SUBJECT: Beaver Valley Power Station - Unit No. 2
Docket No. 50-412
Open Item Response

This letter forwards responses to the issues listed below. The following items are attached:

Response to Outstanding Issue 63 of the
Beaver Valley Power Station Unit No. 2
Draft Safety Evaluation Report

Modified Control Room
Emergency Pressurization
Air System

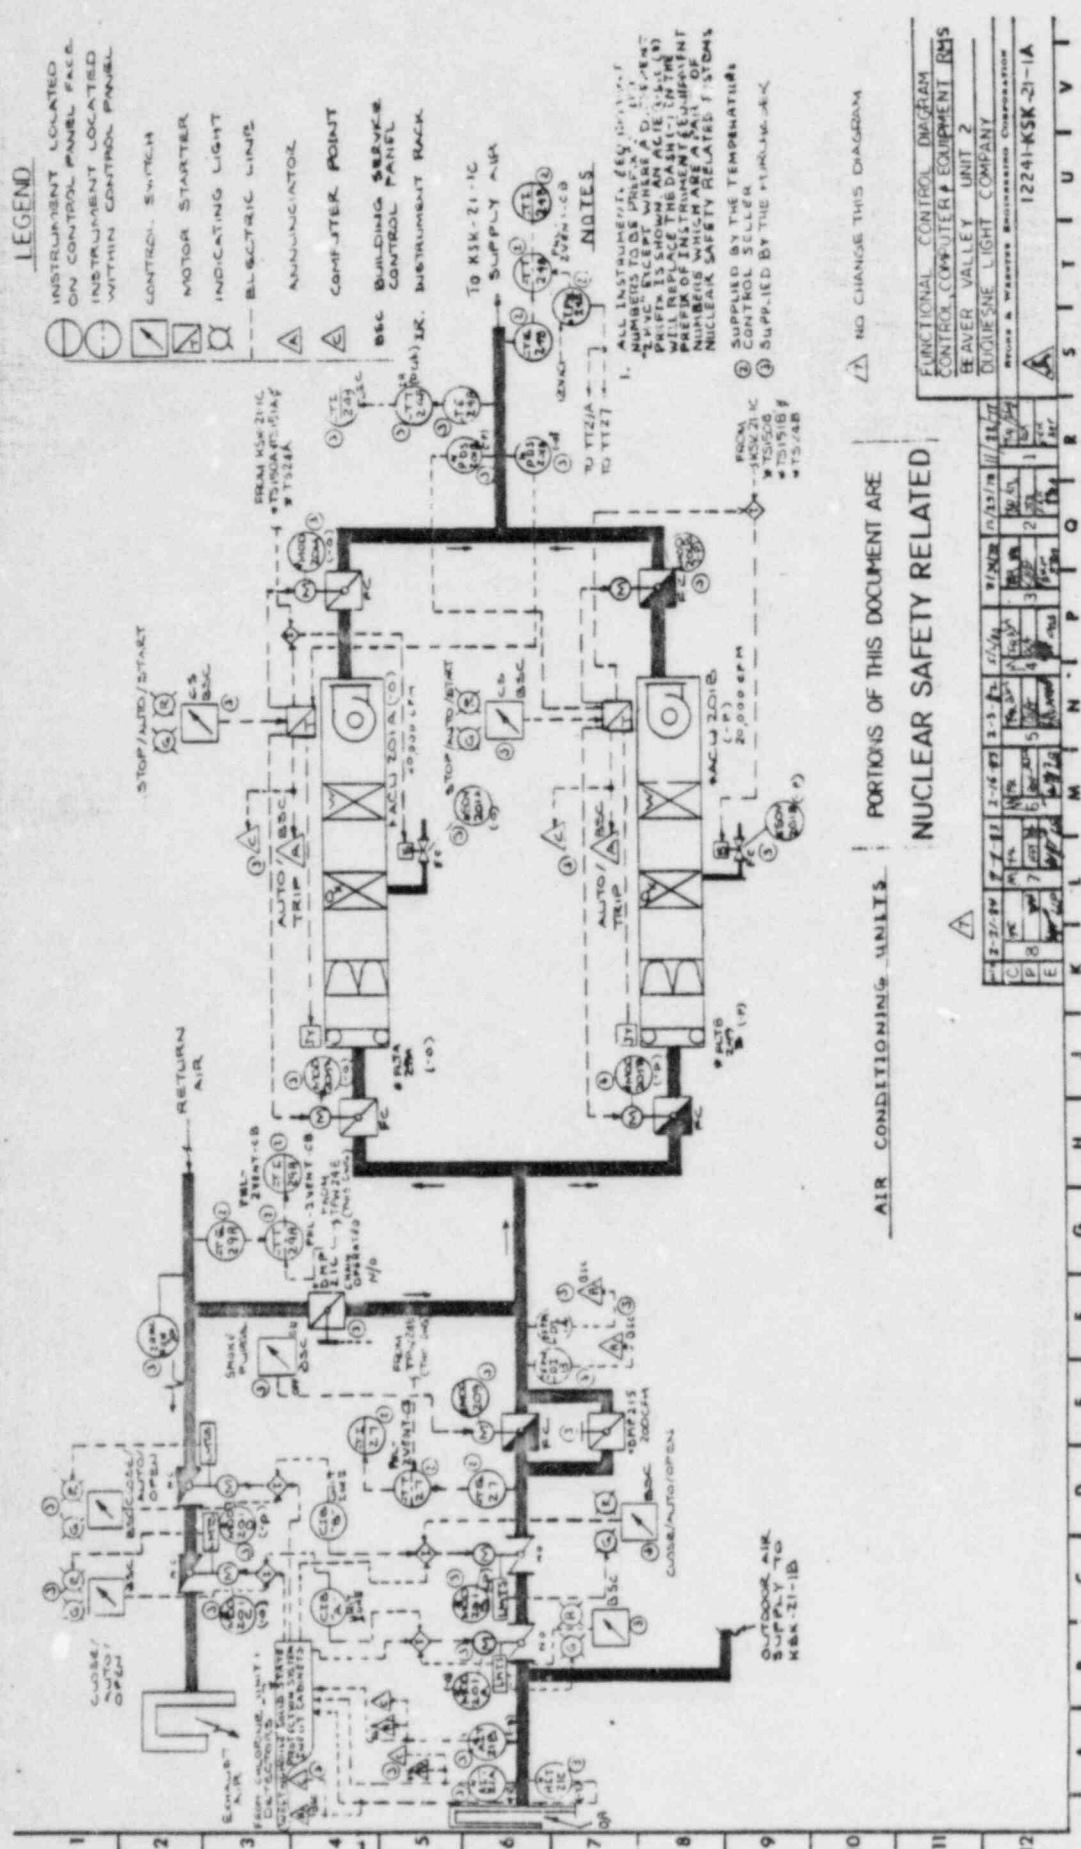
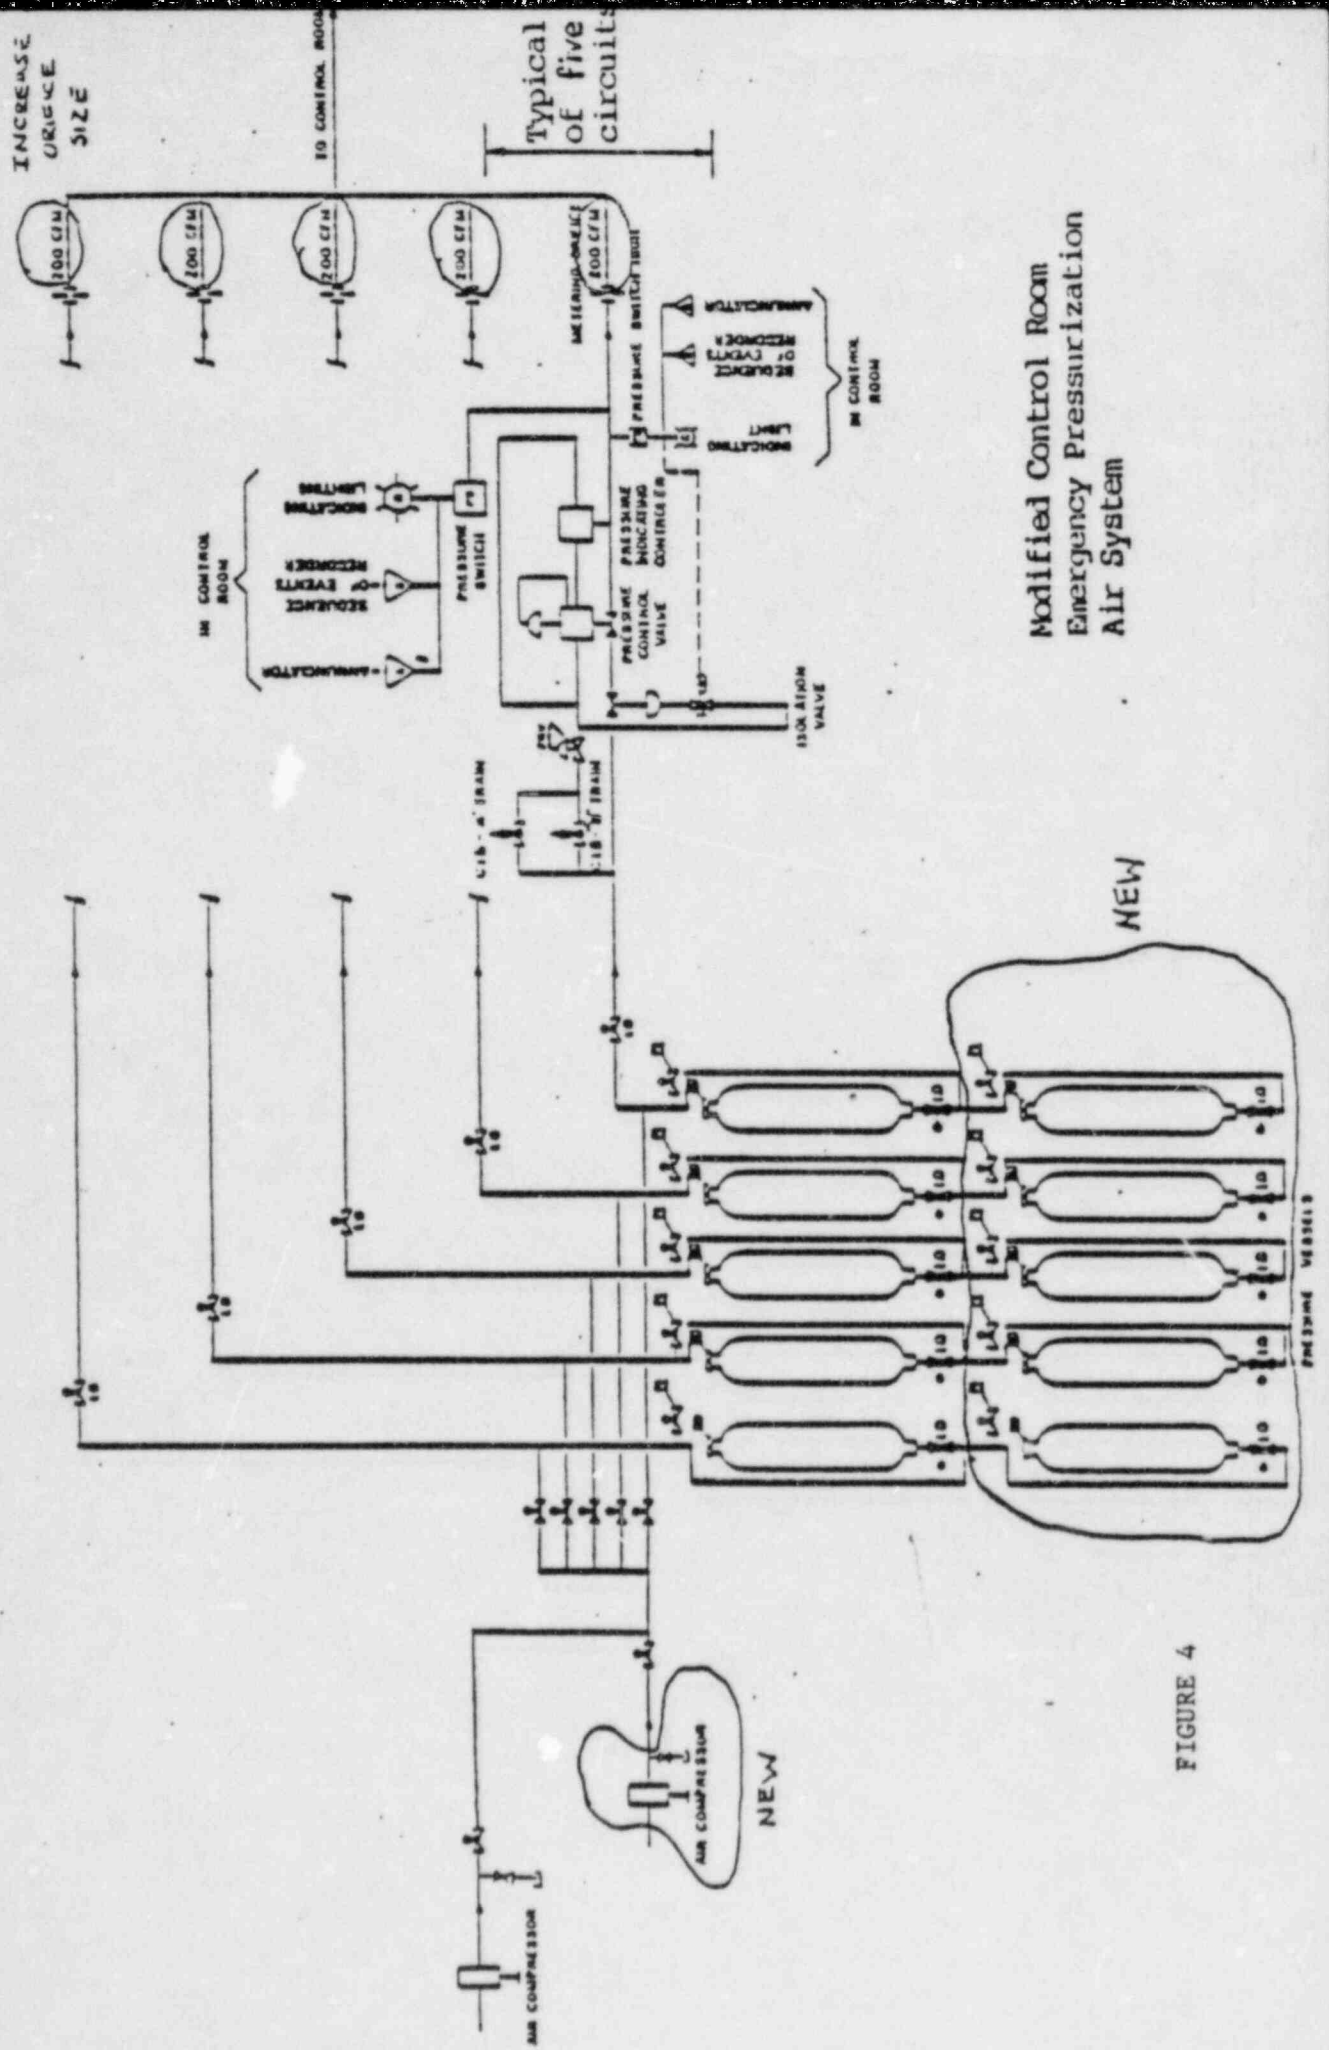
Draft SER Section 7.3.3.8: Control Room Isolation (excerpt)

The applicant has indicated that the design of the control room and pressurization system is incomplete at this time. Based on its review of preliminary information, the staff has expressed a concern that the design, which is integrated into the current control room isolation and pressurization system, may not meet the requirements of GDC 5.

The ventilation isolation dampers for each ventilation system are powered from the emergency busses on the corresponding unit. Control signals are provided from both units to isolate ventilation in the event of a control room isolation signal on either unit. The attached Figure 1 shows the control signal interrelationships and isolation methodology. In order to assure that the isolation dampers are shut when isolation is required, they will be shut when the associated unit enters mode 5 or 6 (cold shutdown or refueling). Thus, the dampers will be pre-positioned in their safety position in the event that redundant electric power is not available. Figures 2 and 3 (attached) show the functional control relationships of the Beaver Valley Unit 2 control room ventilation system.

The CREBAPS volume is being enlarged as shown on Figure 4 to provide sufficient capacity to pressurize the combined control room. The isolation valves on the CREBAPS are powered by Unit 1. As in the case of the isolation dampers, control signals are provided from both units so that if initiation is required by either unit, pressurization air will be provided to the control room. In order to assure that redundant electrical power is available to these valves, transfer switches will be used to transfer the isolation valve power supply to Unit 2 if Unit 1 enters mode 5 or 6. By using "break-before-make" transfer switches, redundant power sources will be available to the valves at all times and yet the Unit 1 and 2 emergency power sources will remain independent.
